Application for Licence Amendment

Licence Number	L9402/2023/1
Licence Holder	Carnegie Gold Pty Ltd
ACN	117 116 097
File Number	DER2023/000375
Premises	Riverina Gold Operations Within Mining Tenement M30/256 As defined by the premises map within Schedule 1 in Licence L9402/2023/1.
Date of Report	29 October 2024
Decision	Revised licence granted

Figure 1: Proposed and existing prescribed premises boundary

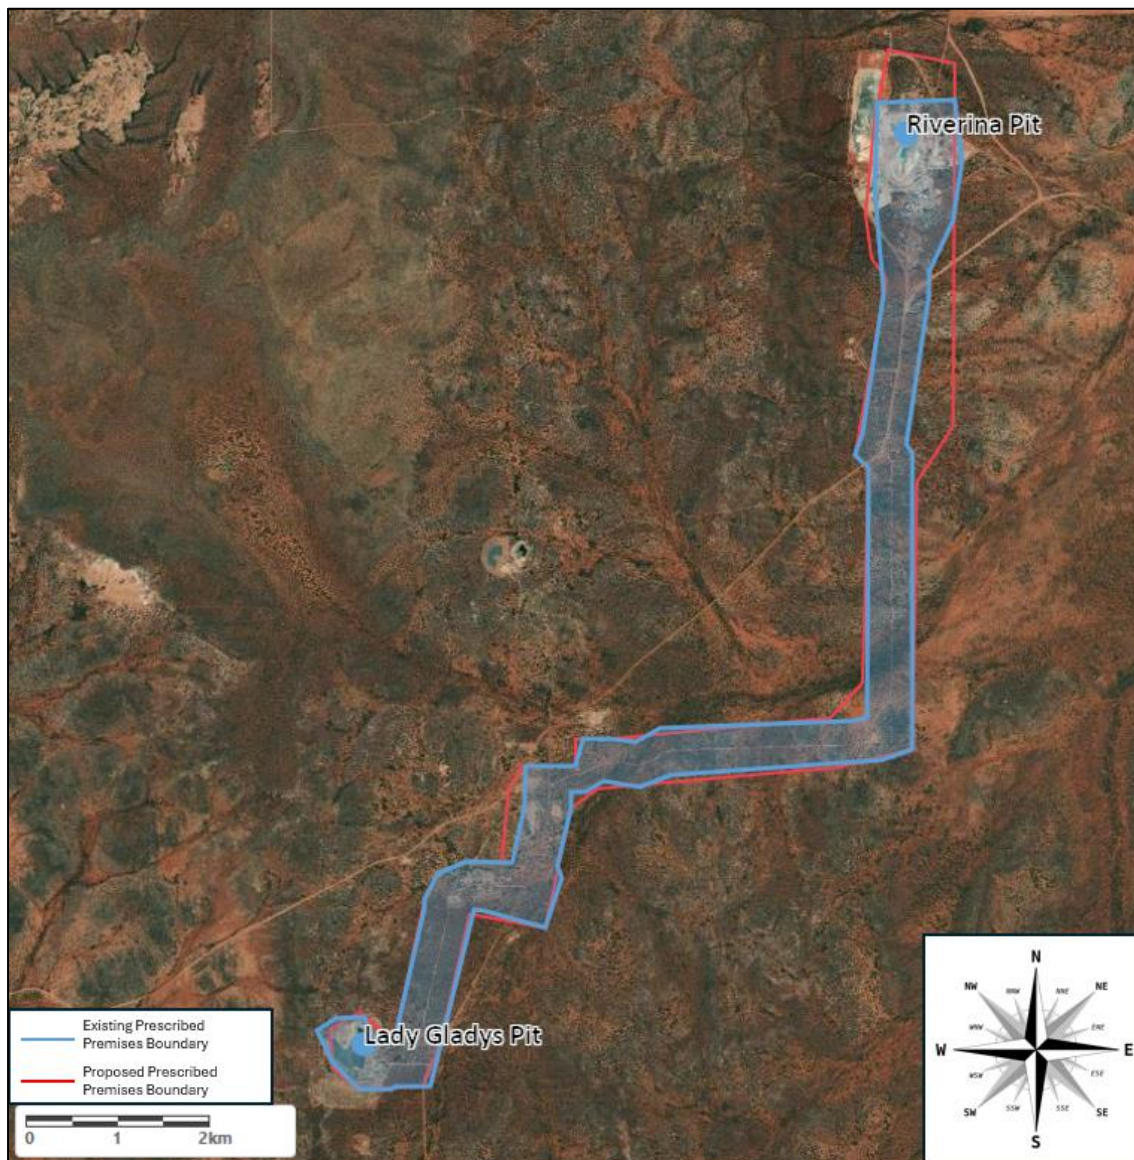
The Licence Holder has requested an amendment to the prescribed premises boundary as presented in Figure 1. The change in the premises boundary is a result to shift the pipeline corridor slightly out to the proposed Credo conservation park cadastral boundary and also to align with the existing clearing permit CPS 8854/2. The department has reviewed the amendment and does not consider this to materially alter potential risks to sensitive receptors. Therefore, the amendment has been granted and is not assessed further in the risk assessment.

Condition no.	Proposed amendments
Condition 3	Amended inspection of pipeline and catch sumps from twice daily to daily; and Daily inspections of Lady Gladys Pit from daily to weekly.
Condition 4	Amended freeboard requirement at Lady Gladys Pit from 10 m to 5 m.
(new) Condition 5	Added requirement for submission of a trigger action response plan if Lady Gladys water level reaches 10 m below the embankment.
Condition 13	Added requirement for Licence Holder to submit and water balance for Lady Gladys Pit within the Annual Environmental Report.
(new) Condition 16	Added construction requirements for the new proposed dewatering pipeline.
(new) Condition 17	Added condition for submission of Environmental Compliance Report.
(new) Condition 18	Added condition for requirements of the Environmental Compliance Report.
Definitions	Defined 'TARP'.
Schedule 1, Figure 1	Updated figure with amended prescribed premises boundary.

Figure 2: Riverina South staging tank water quality

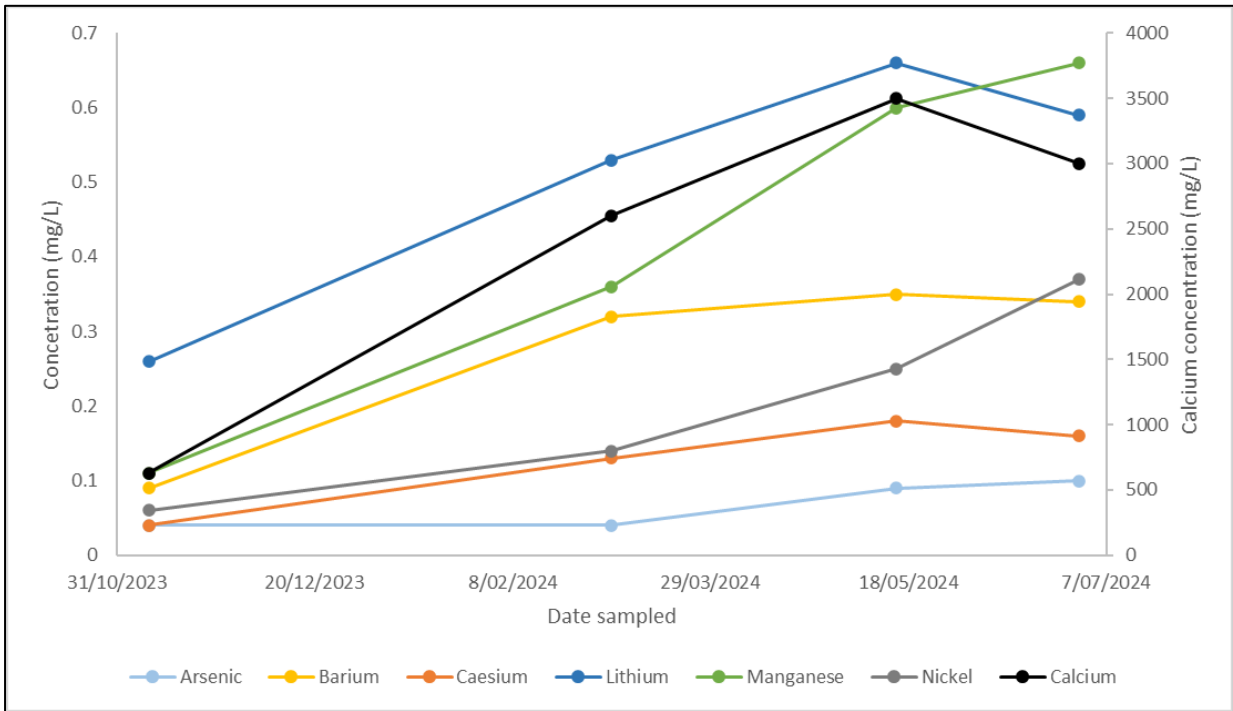
In addition, quarterly water monitoring conducted at the Riverina South staging tank indicated increasing concentration of parameters measured (Table 3; Figure 2), including the four parameters that have exhibited increased concentrations at the Lady Gladys Pit. Furthermore, the salinity of the mine dewater appears to be increasing over time, based on total dissolved solid (TDS) levels (Table 4; Figure 3). The department understands that this trend is due to the increasing depth of dewatering activities at the Riverina underground mine, where the salinity of natural groundwater is increasing. The highest recorded TDS for mine dewater at the Riverina underground mine was 140,000 mg/L (OBM 2024a). Based on existing monitoring information, the discharge of mine dewater from the Riverina underground mine may be contributing to elevated salinity as well as metal and metalloid loading at Lake Gladys Pit, though further monitoring is required to identify clearer trends.

Figure 4: Lady Gladys Pit level (sourced from OBM 2024b)

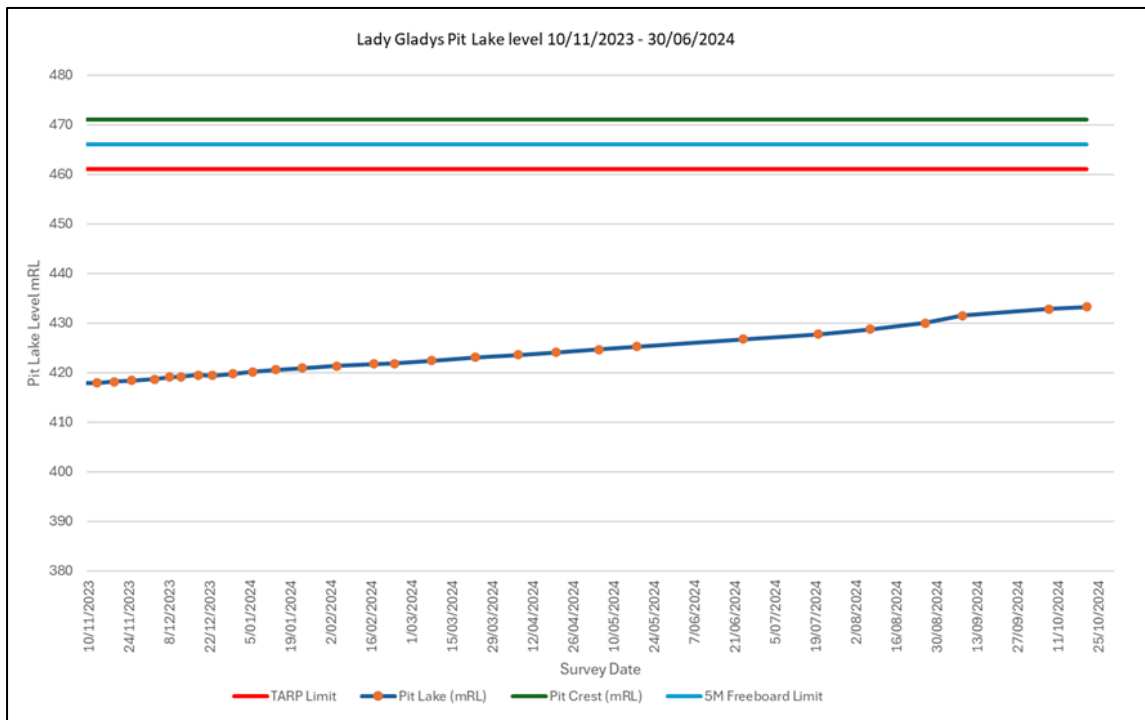
The Licence Holder has proposed to decrease the freeboard height requirement at Lady Gladys from 10 m to 5 m. Since the commencement of discharge in 2023, the water level within Lady Gladys Pit has increased by approximately ~7 m, with over 40 m in freeboard at the time of the assessment (Figure 4).

In considering this, the department has considered the proposed reduction in freeboard level and has amended the freeboard to 5 m. However, the rate of rise for water level within the pit was also noted, as well as the significant increase in discharge throughput proposed under this amendment, which may present an increased risk of overtopping. Specifically, under the maximum discharge rates (i.e., 1,900,000 tonnes per annum), Lady Gladys Pit would only have sufficient capacity for approximately 2.7 years, which is less than the current LOM of five years.

Lady Gladys Pit freeboard	Daily	Monthly	Weekly	<p>The department notes the rising trend in pit lake elevation (~7 m), based on the previous year of monitoring (Figure 4). In considering the increase in throughput for the discharge of mine dewater into the Lady Gladys Pit, pit lake elevation may continue to rise.</p> <p>The department has amended the inspection requirement for the freeboard inspection requirement for Lady Gladys Pit from daily to weekly, as the department considers monthly inspections of the freeboard to be too infrequent especially when water levels are close to the freeboard and the TARP level where immediate action is required.</p>

Consequently, the department has also included an additional condition to require the Licence Holder to submit a TARP if water levels within Lady Gladys reaches 10 m below the pit crest (new condition 5), noting that the Licence Holder had previously committed to implementing a TARP should pit water level reach 15 m below pit crest. Furthermore, condition 13 of the amended licence has been updated to require the submission of an annual water balance for Lady Gladys Pit.
